**RE: Sotogrande Housing  
Conceptual Grading and Drainage Plan  
Stamp Date: 10/3/17  
Hydrology File: M15D023H**

Based upon the information provided in your submittal received 10/3/2017, the Conceptual Grading and Drainage Plan **is not** approved for Preliminary Plat and Site Plan for Building Permit. The following comments need to be addressed for approval of the above referenced project:

CIVD1

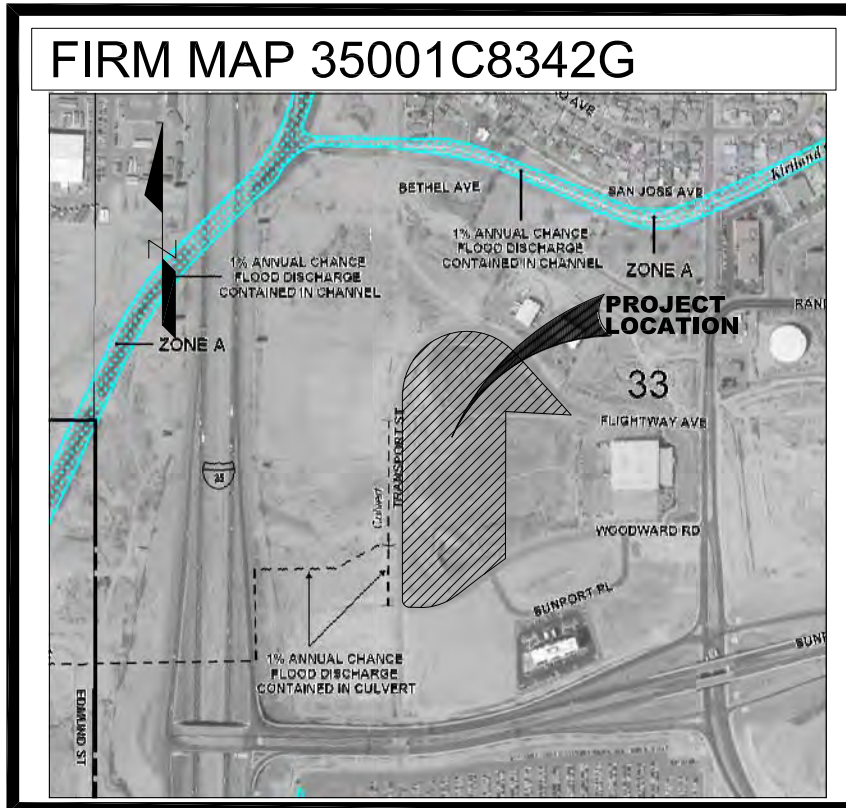
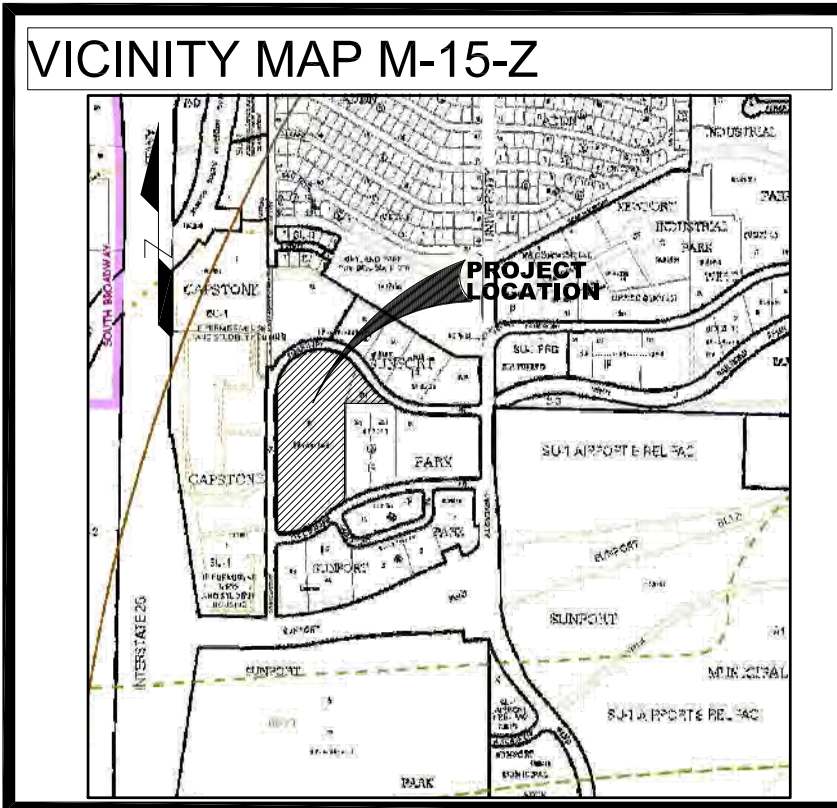
1. Please provide the benchmark information for the survey contour information provided.
2. Sheet CIVD1. Under Offsite Flows, Lot 2-A-2 is currently under construction as a Comfort Suites Hotel. They are installing a retaining wall along their western property line. They are building a detention pond which captures the upstream drainage from Lot 2-A-3 and is designed with a release rate of 1.4 cfs at the northwest corner of their property.

CIVD2

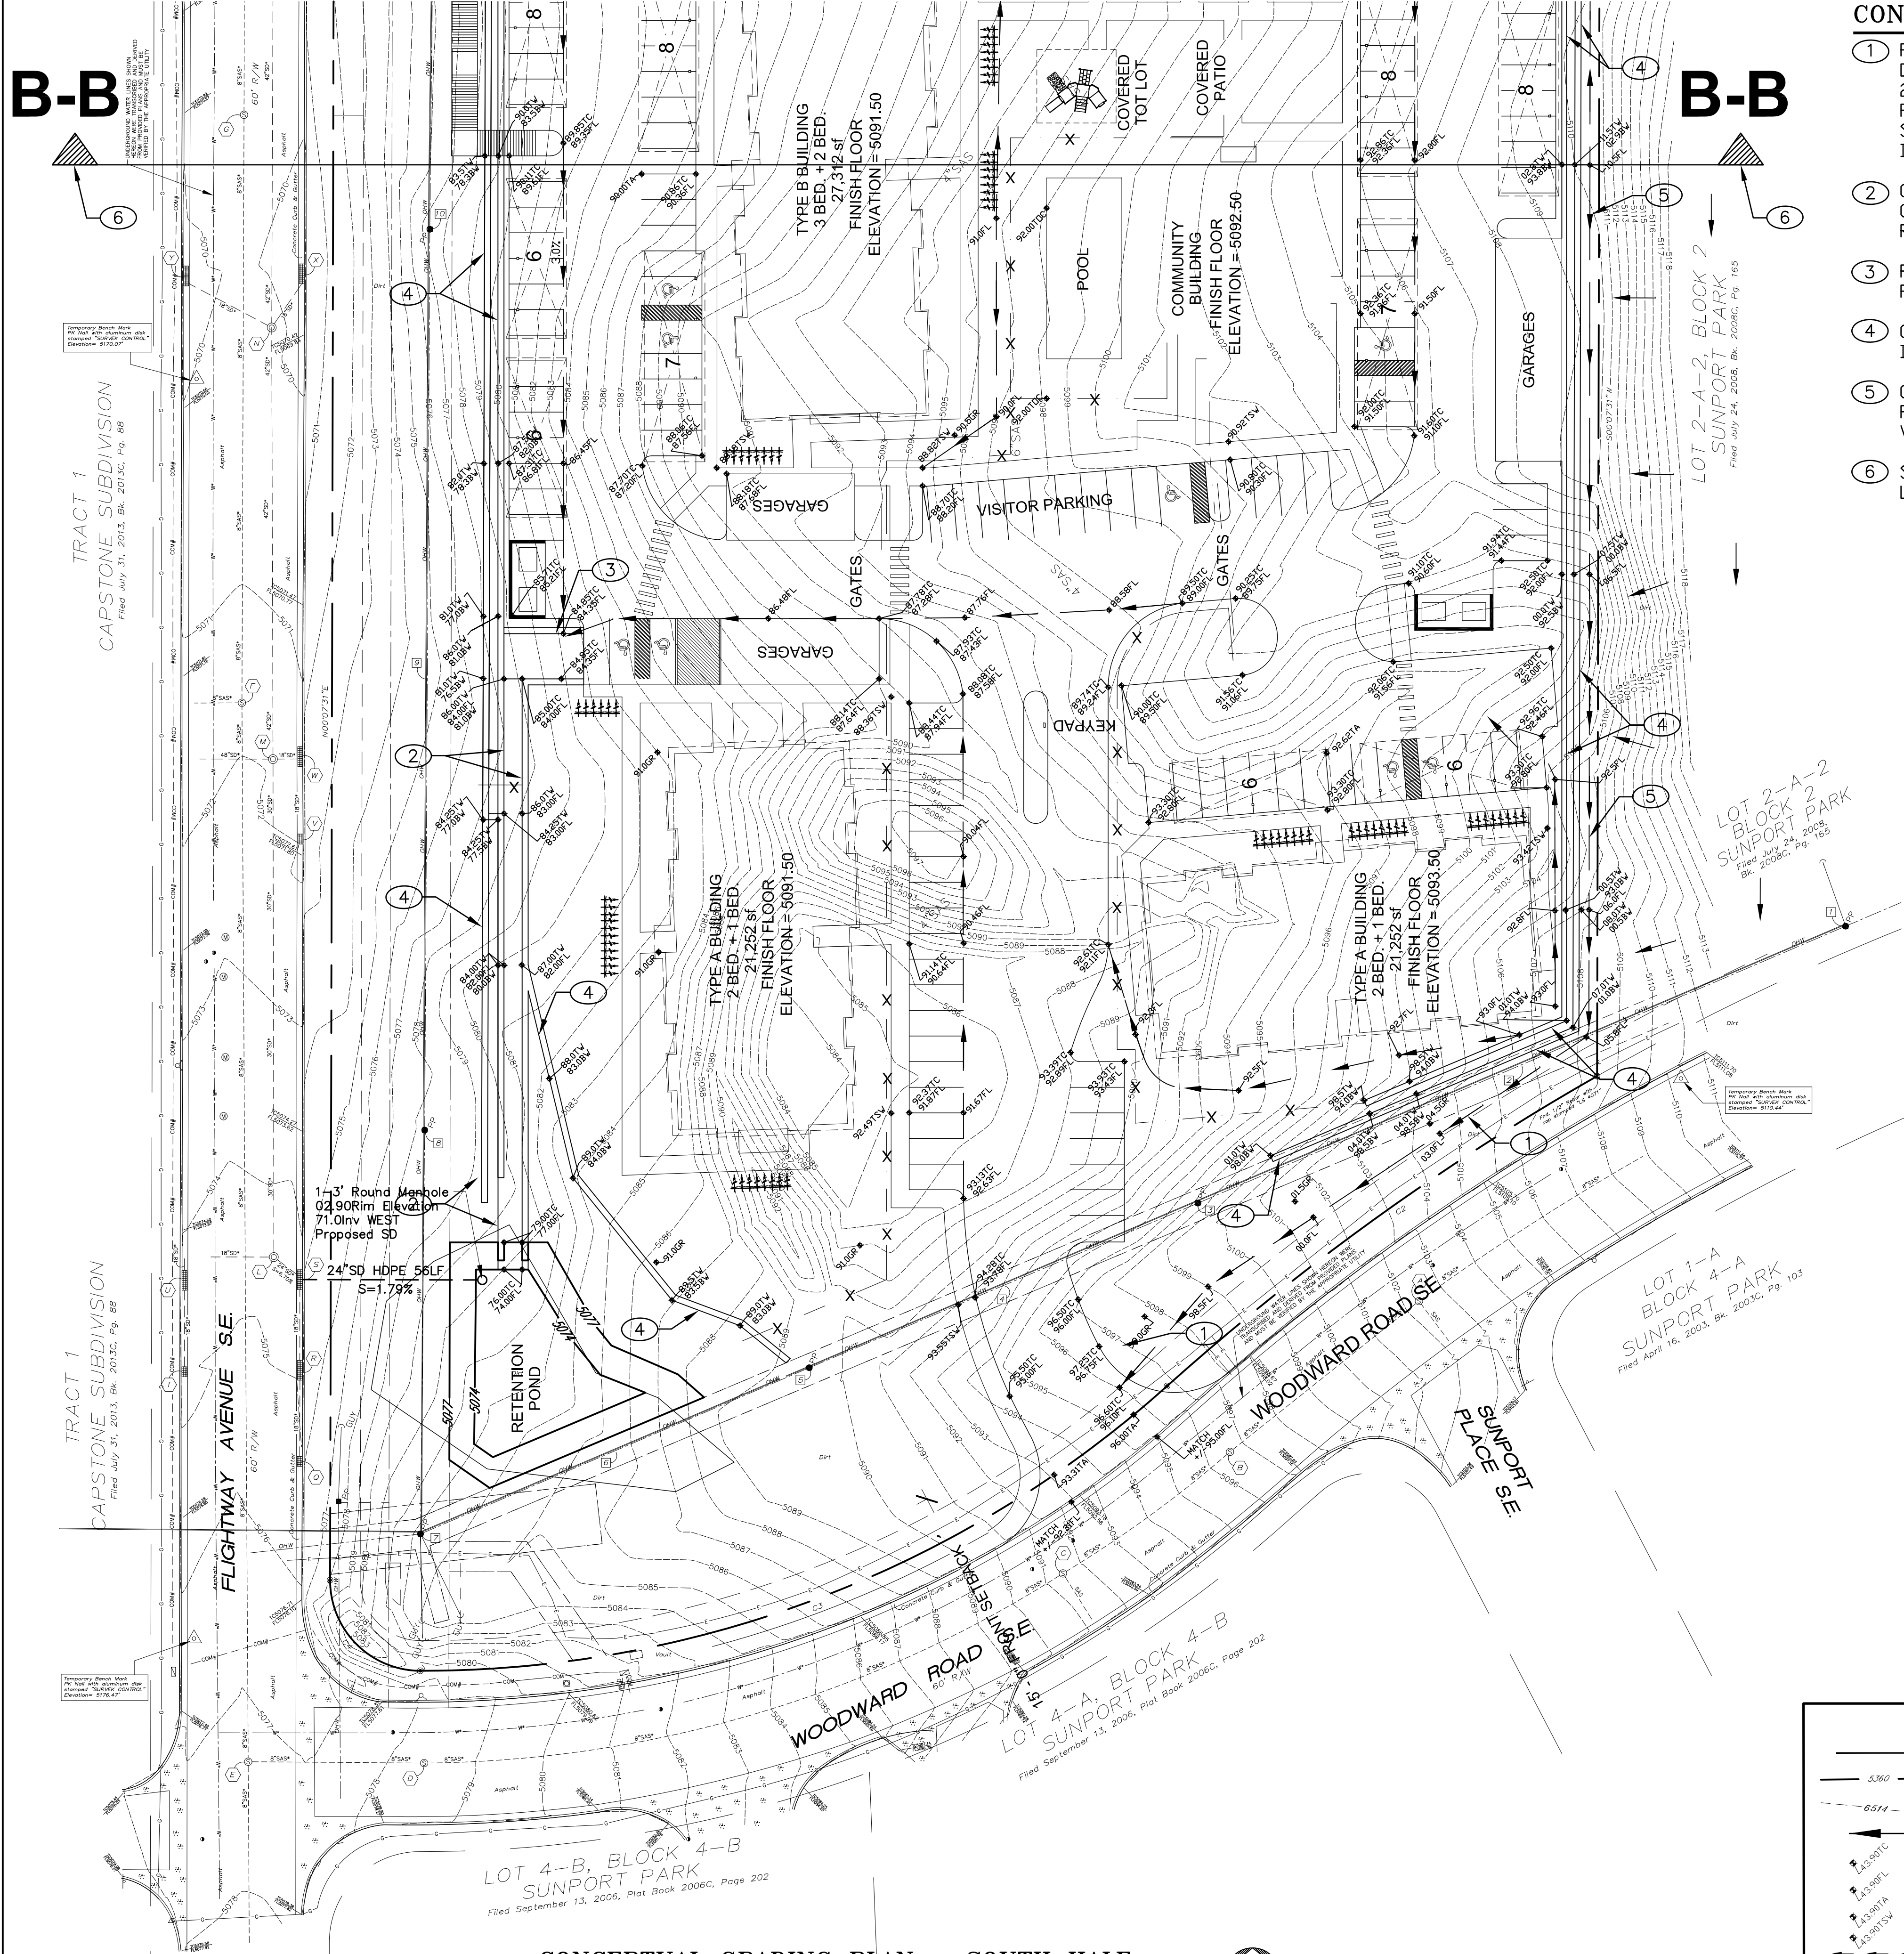
3. Sheet CIVD2 & CIVD3. Please add proposed contour lines throughout the project. Since there are multiple building, the proposed contours will help spot drainage issues. I'm particularly concerned with how you are tying back into the existing contours along Woodward Road and Flightway Avenue.

4. Sheet CIVD2 & CIVD3. Please label both ponds as Detention Pond w/ First Flush rather than Retention Pond.
5. Sheet CIVD2 & CIVD3. Please provide pipe calculations showing that both outfall pipes can handle the required release rates for each pond.

6. Sheet CIVD2 & CIVD3. Please fix the leaders on the Construction Note callouts. Some of the arrows are not pointing to the right object.
7. Sheet CIVD3. I believe you have a design changed that was not corrected. You call out a 22 feet curb cut for drainage access into the proposed detention pond. However this is just a sidewalk right behind a proposed Garage. You also are showing what appears to be a concrete channel at the south side of the detention pond that extends into two parking spaces but this is not called out. Please clarify which one is the drainage structure for the detention pond.

**CONCEPTUAL**  
**CROSS**  
**SECTIONS**  
**CIVD4**

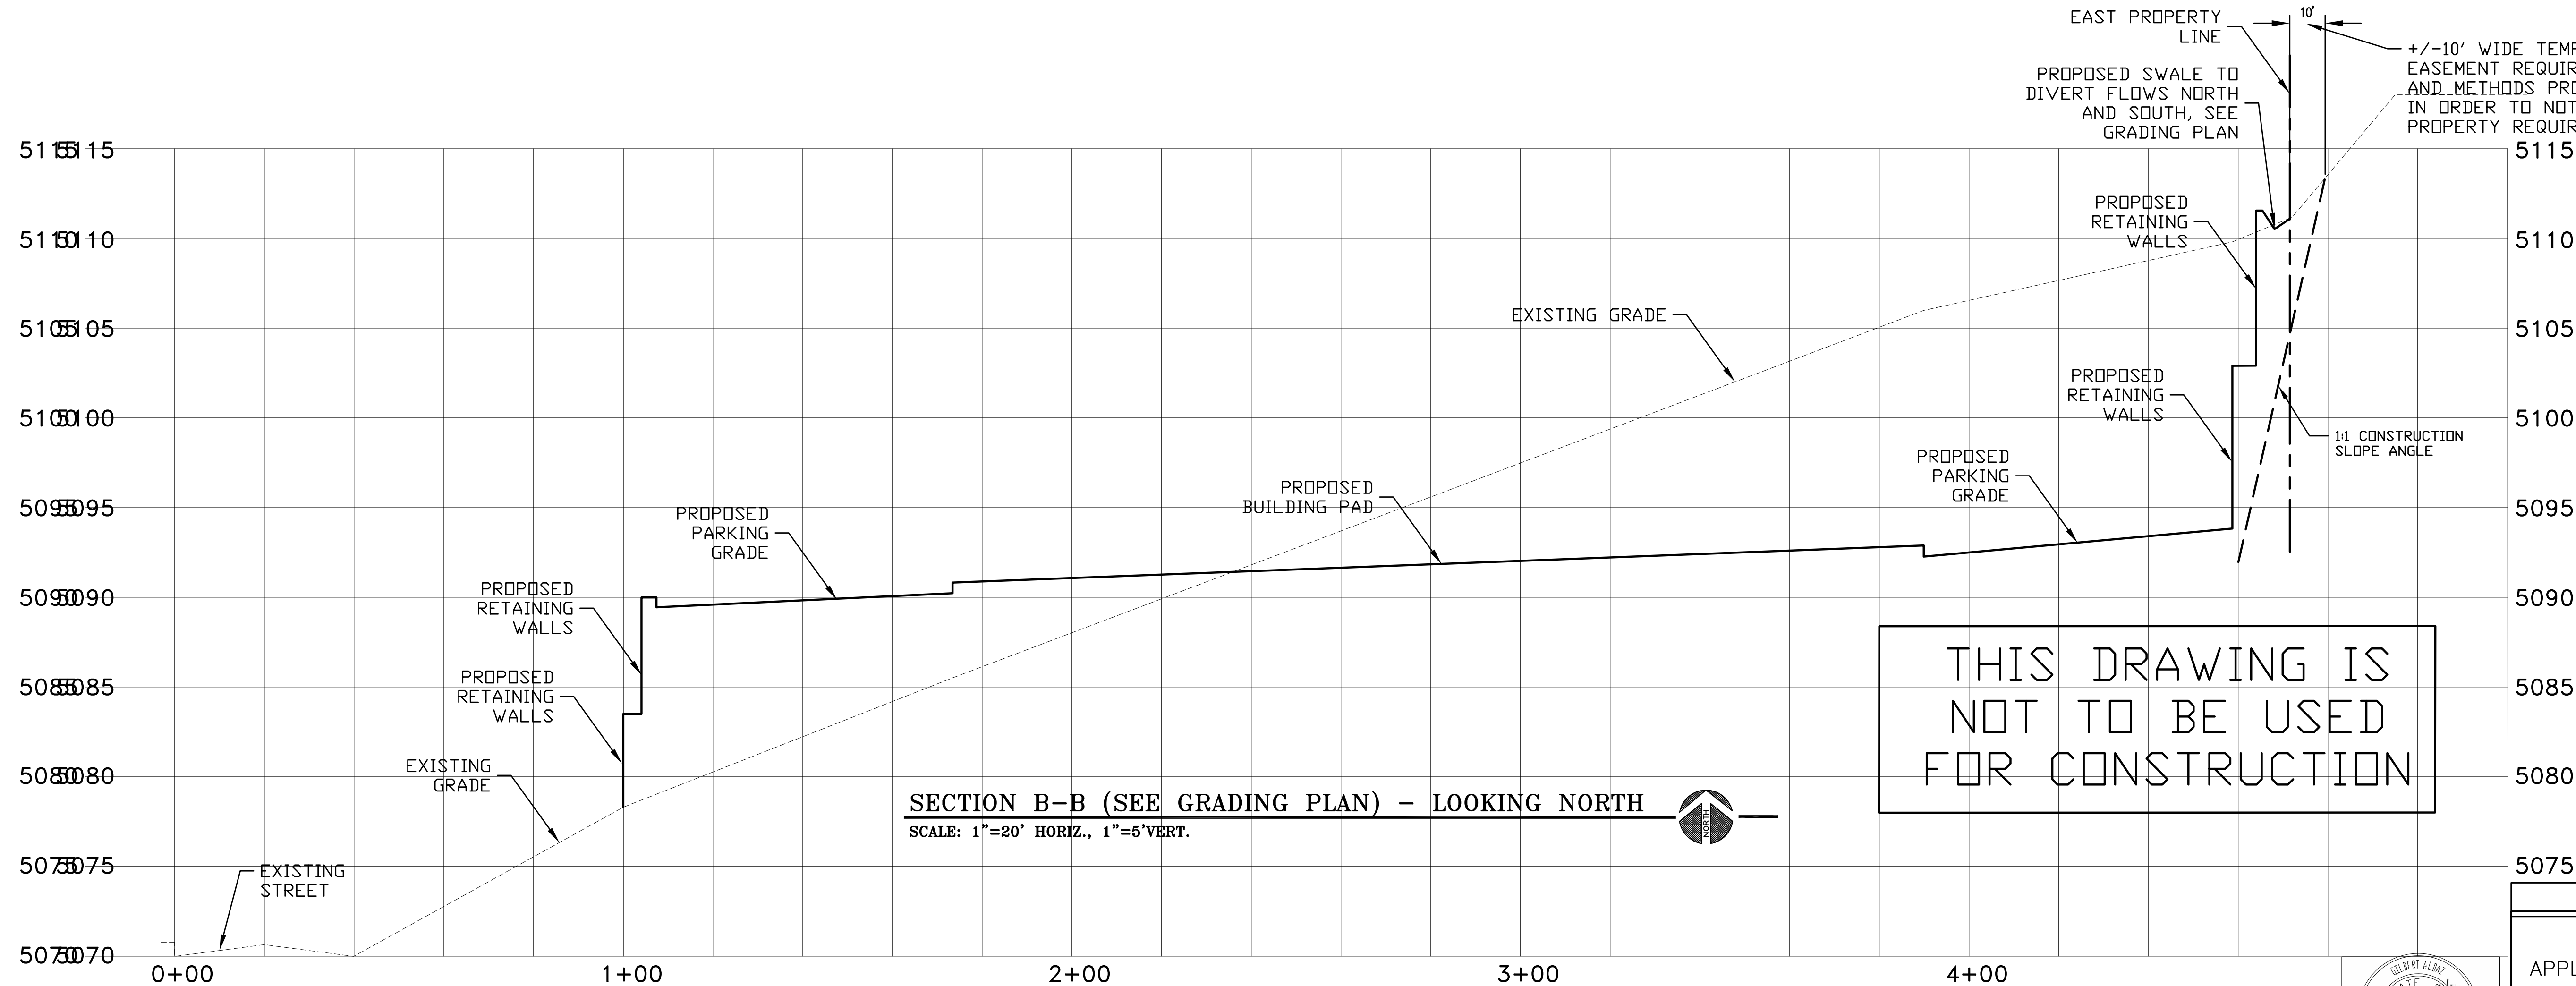
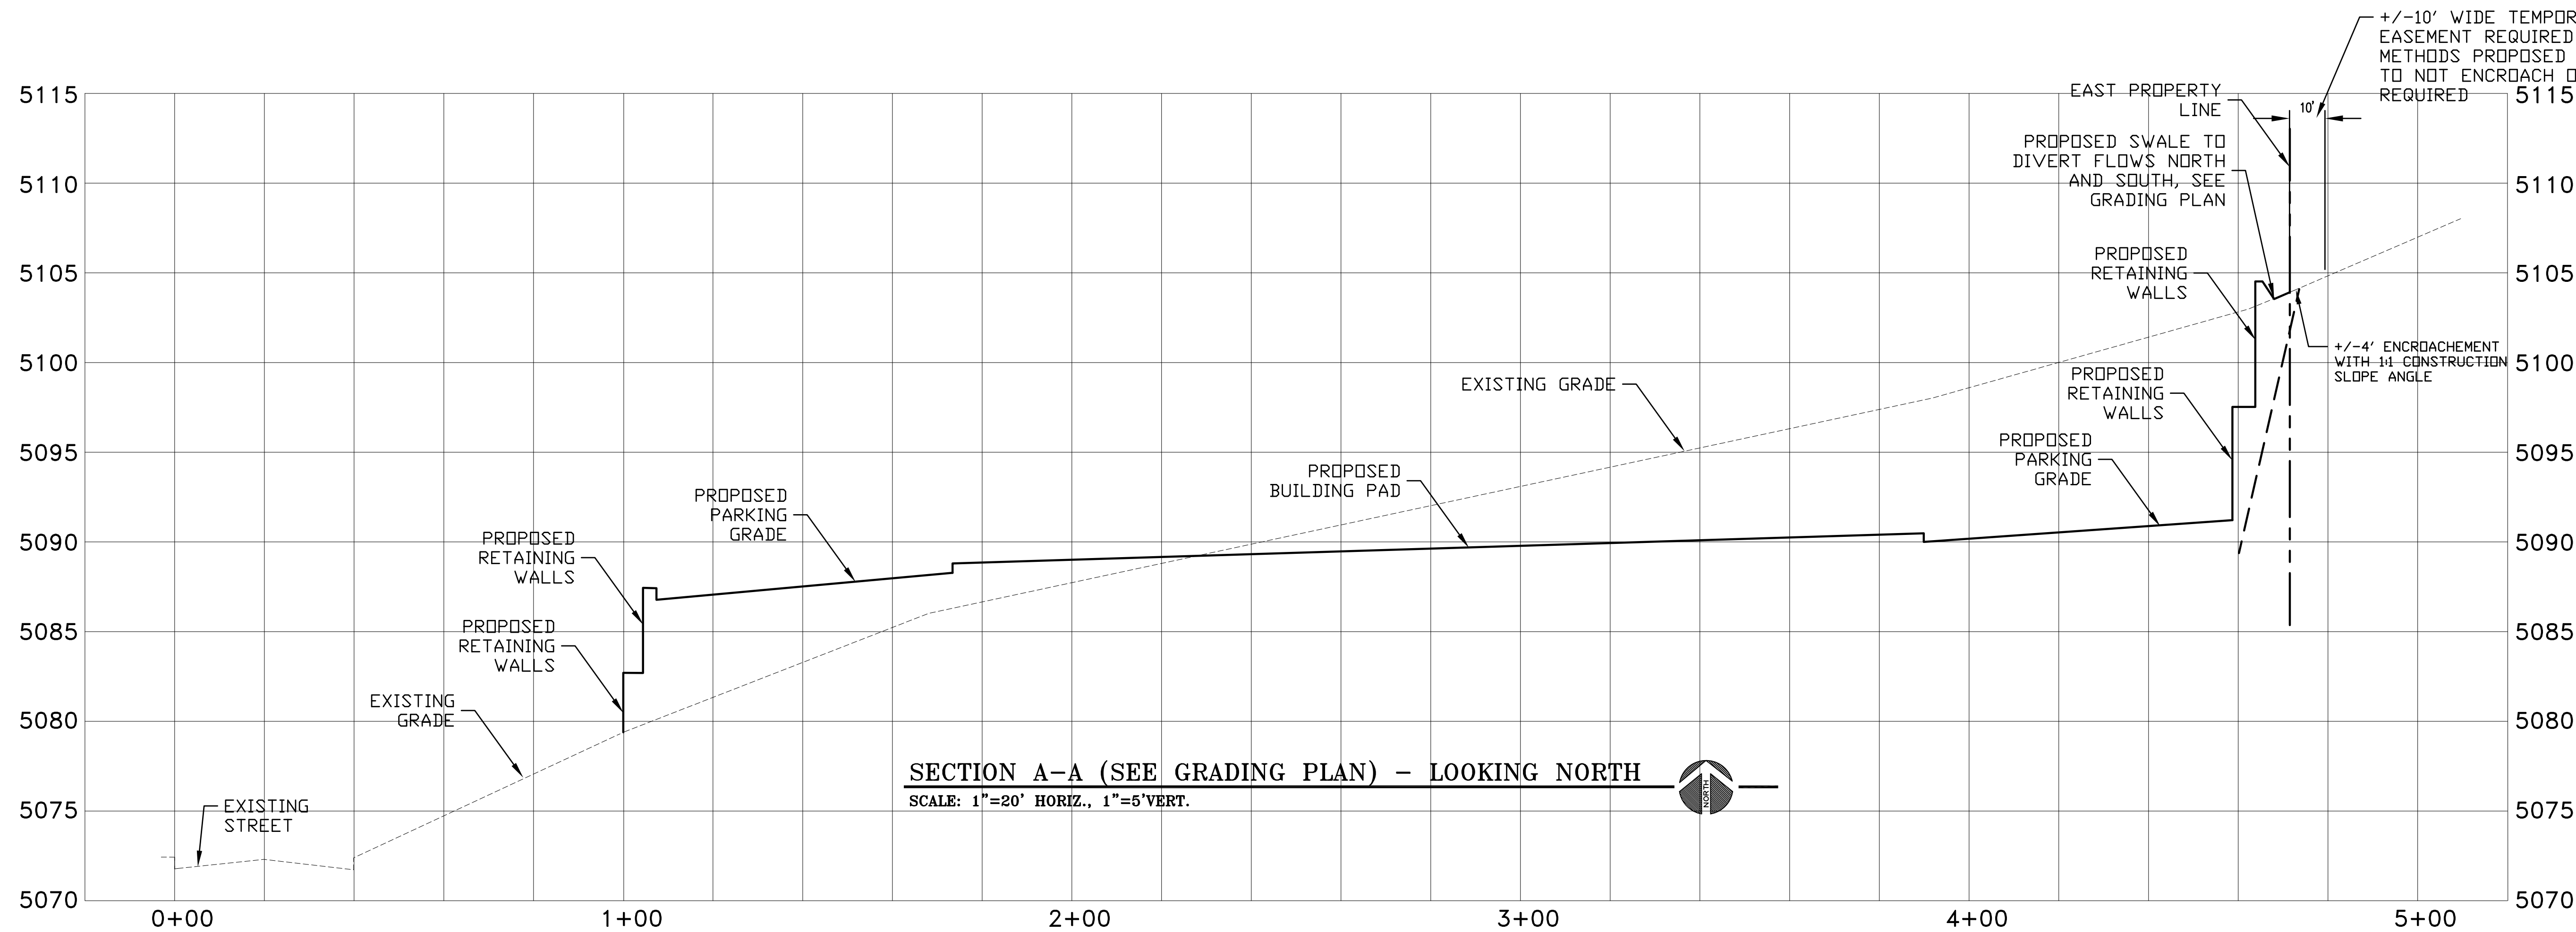
8. Sheet CIVD4. Please show and label the western property line and label the Flightway Ave R.O.W.
9. Sheet CIVD4. It states that a 10 feet wide temporary construction easement required on the adjacent Lot 2-A-2. As I stated in Item #2, Lot 2-A-2 is currently under construction as a Comfort Suites Hotel and a temporary construction easement will not be able to get since there will be a retaining wall built on Lot 2-A-2.
